**OPEN SPACE ADVISORY BOARD**  
Wednesday, March 2, 2011, 1:30 P.M.  
8<sup>th</sup> Floor Conference Room  
City Hall Building, 2 Civic Center Plaza

## *City of El Paso – City Plan Commission Staff Report*

**Case No:** SUB11-00043 Cimarron Sage Land Study  
**Application Type:** Land Study  
**CPC Hearing Date:** March 10, 2011  
**Staff Planner:** Raul Garcia, 915-541-4935, [garcia1@elpasotexas.gov](mailto:garcia1@elpasotexas.gov)

**Case No:** SUB11-0045 Cimarron Sage Unit One  
**Application Type:** Major Preliminary  
**CPC Hearing Date:** March 10, 2011  
**Staff Planner:** Frank Delgado, (915) 541-4238, [delgadofx@elpasotexas.gov](mailto:delgadofx@elpasotexas.gov)  
**Location:** South of Paseo del Norte Road and East of Resler Drive  
**Legal Description Acreage:** 61.11 acres  
**Rep District:** 1  
**Existing Use:** Vacant  
**Existing Zoning:** C-1 (Commercial), C-3c (Commercial/condition) & R-3A (Residential)  
**Proposed Zoning:** C-1 (Commercial), C-3c (Commercial/condition) & R-3A (Residential)

1. Location Map
2. Aerial Map
3. Preliminary Plat
4. Application

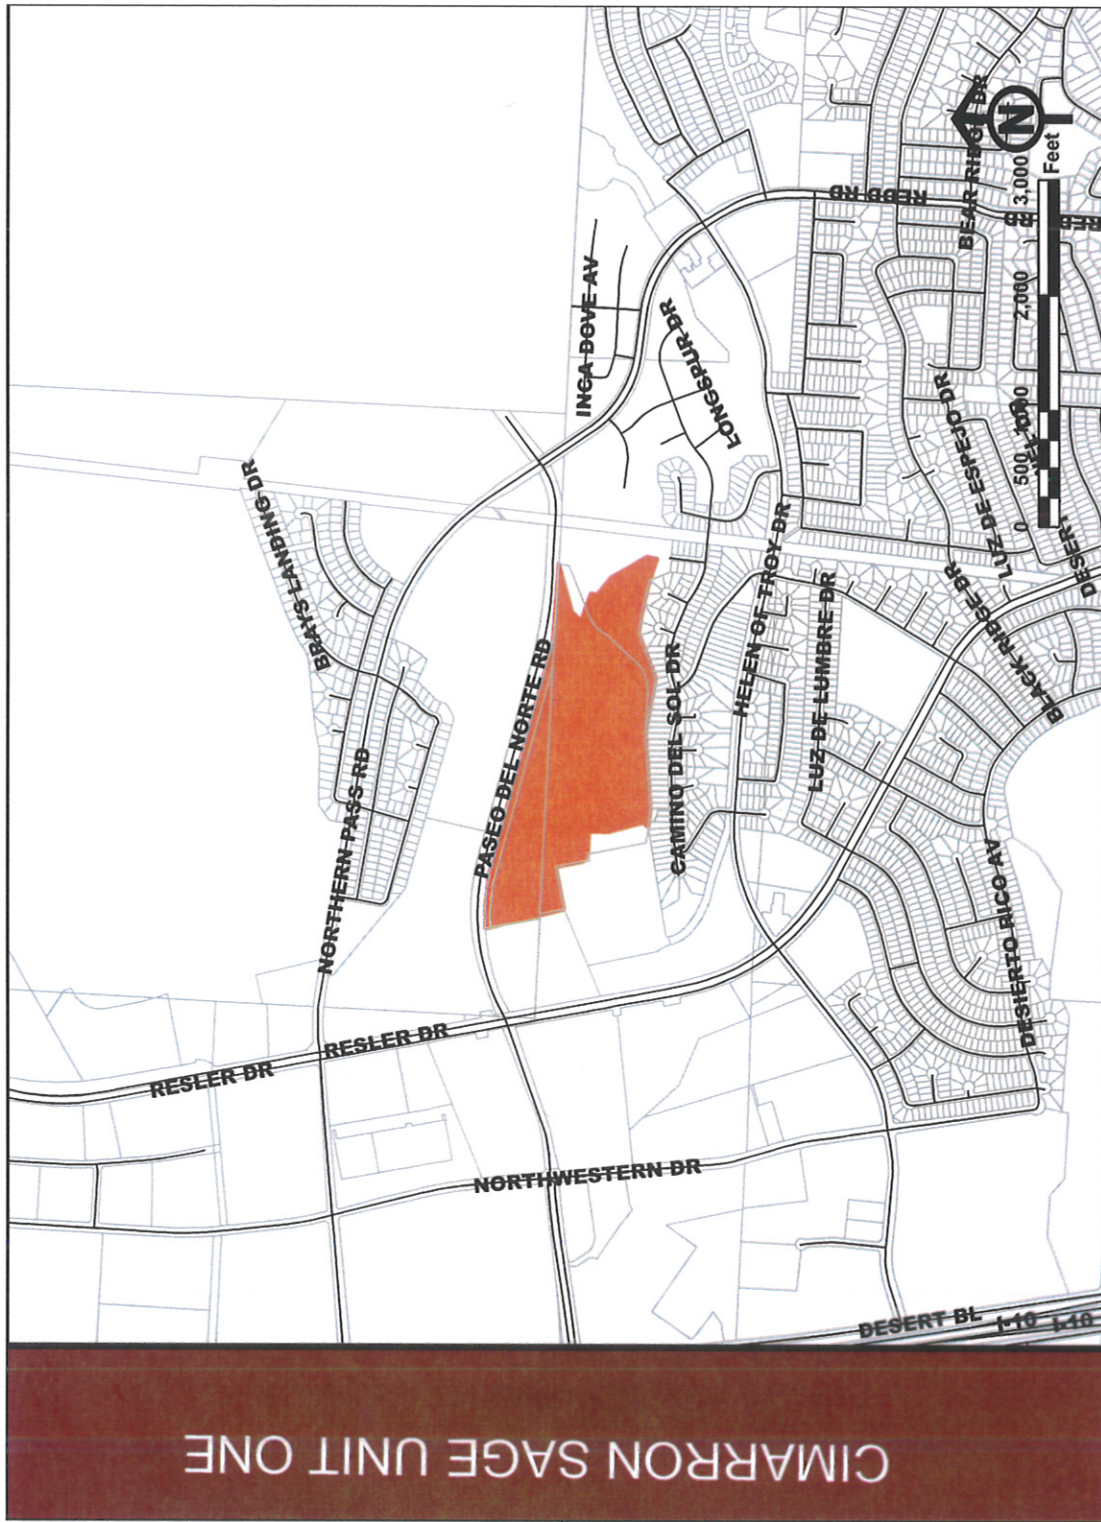
We have reviewed subject plan recommend **Approval**, however; developer/engineer needs to address the following comments:

1. Provide flood zone designation, and clarify flood zone boundaries limits and label on the plat.
2. Provide print-out of the mathematical closure of the exterior boundary of the subdivision indicating the error of closure.

5. There are no existing improvements shown to provide access to this subdivision. Legal access shall be provided to this proposed subdivision.
6. Proposed survey monuments shall be clearly distinguished.

7. Verify all provided and applicable street cross-sections, classifications and pavement widths and provide design modification letter where applicable.

2. During the improvement plan phase provide the appropriate earth retention walls or structures for Lots 24 – 31 adjacent to the Pond No. 4 slope.
3. Provide additional right-of-way for access to the proposed open space (Lot 54, Block 1) if the open space is to be maintained by the City of El Paso.

4. EPWU requires additional drainage right-of-way (from a public street) for access to the existing Pond 3 drainage outfall structures.
5. At the improvement plan stage provide erosion control plans for the outfall structure from Pond No. 3, the outfall structure into Pond No. 4, the structure discharging into Flow Path No. 38A, and all abutting lots to Flow Path No. 38A.

6. Provide additional retention of stormwater runoff at the park site. EPWU encourages the use of recessed landscaping and rainwater harvesting for stormwater retention.

7. The proposed structures discharging directly into Flow Path No. 38A do not coincide with the preservation of natural arroyos. EPWU encourages the Developer to consider alternate stormwater management plans that avoid discharging directly into Flow Path No. 38A. EPWU recommends the use of nonstructural stormwater management, such as the preservation of greenspace and other conservation areas, to the maximum extent practicable.

8. Identify or remove solid lines shown throughout the proposed preliminary plat. For example, the line that passes through Lots 2 and 25 on Block 7.

1. Show street widths on the face of the subdivision plat.
